CITY OF VANCOUVER
ENGINEERING SERVICES
T.R. Timm, P.Eng., General Manager/City Engineer

MEMORANDUM

TO: Mayor and Council
CC: Judy Rogers, City Manager
Syd Baxter, City Clerk
FROM: Tom Timm, General Manager
SUBJECT: Burrard Bridge Report # 2877

At the June 28, 2005 meeting of the Standing Committee on Transportation and Traffic a number of questions were raised regarding issues related to report #2877, *Burrard Bridge Sidewalk Capacity Improvements for Pedestrians and Cyclists*. This memo addresses those issues. Further delegations and Council's deliberations on this report have been scheduled for July 19, 2005.

Sidewalks through Towers (“pinch points”)

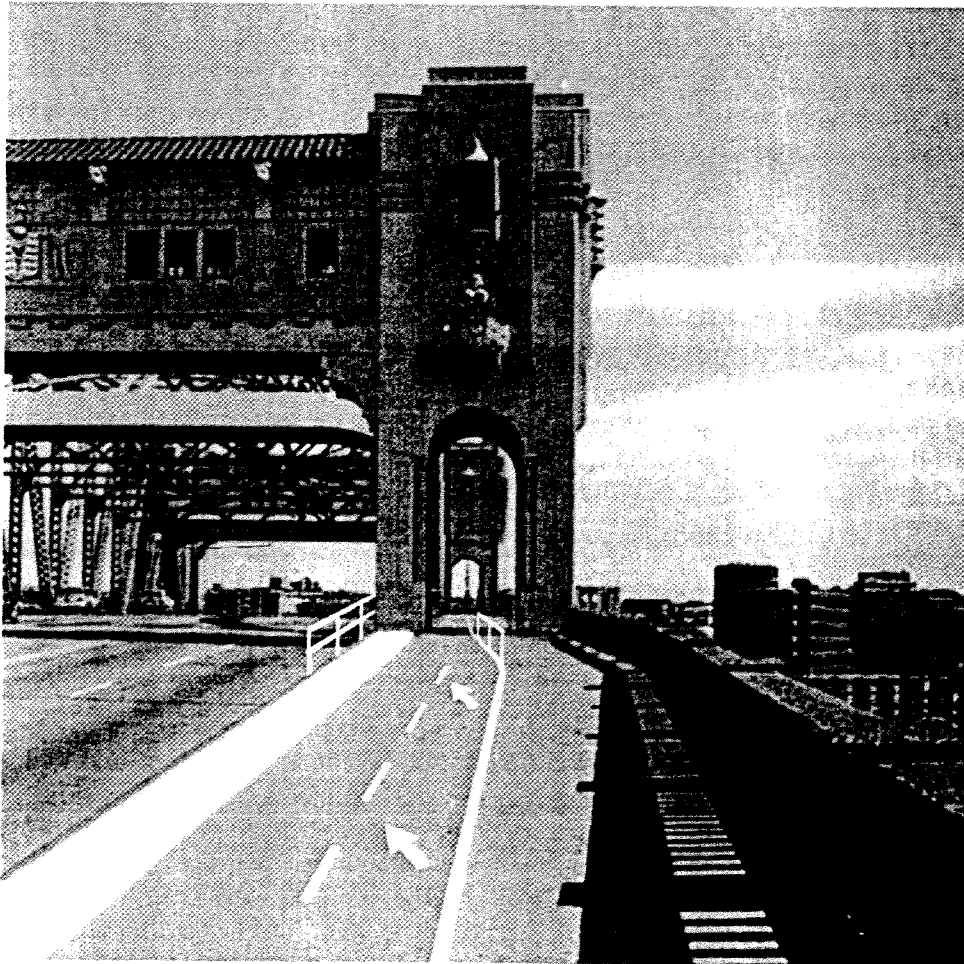
The Burrard Bridge report does not provide details of proposed sidewalk treatments at the “pinch points” of the recommended sidewalk widening option. The figure below shows a concept which includes:

1. pavement markings to direct cyclists into single file as they approach the portals
2. a localized curb-side railing to protect cyclists from vehicular traffic
3. a localized railing between the cycling and walking paths to keep pedestrians from straying into the bike path as the sidewalk narrows, if it found to be necessary

These treatments are designed to address safety concerns at this location while maintaining the integrity of the main bridge towers.

In contrast to a typical intersection, this treatment provides for a continuous flow of cycling and pedestrian traffic and physically separates user groups where a risk of conflict exists. The

“pinch points” are not considered to be a significant detriment to either cyclists or pedestrians. They do not represent a safety concern.

Bridge Capacity

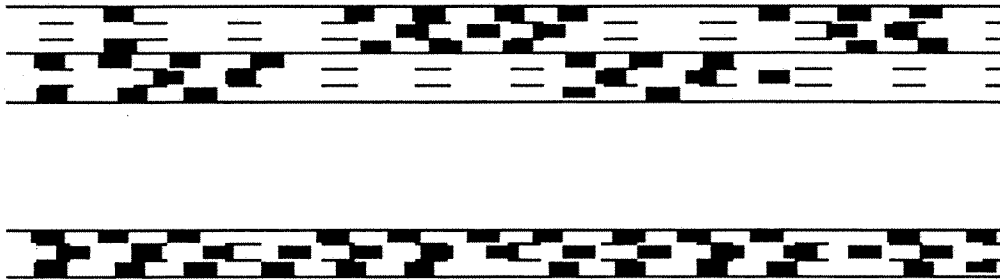
The vehicular capacity of a bridge is governed by the number of lanes and by the ability of the connecting road network to provide access and egress to and from those lanes. In the case of the Burrard Bridge, that connectivity is governed by intersections which allow north/south traffic onto and off the bridge roughly half the time - the remaining time being given to east/west traffic. The result is platoons of vehicles separated by gaps in traffic. In contrast, the Lions Gate Bridge, which carries similar traffic volumes, is fed from the north by a highway interchange and from the south by a 700 m transition from the 7 lanes on Georgia Street. This allows traffic to enter the 3-lane bridge/causeway section in a continuous stream. The effect of this on the bridge capacity is illustrated below.

Because of this platooning effect, bridges with bridgehead traffic signals will have roughly half the vehicle capacity of similar bridges with free-flow approaches.
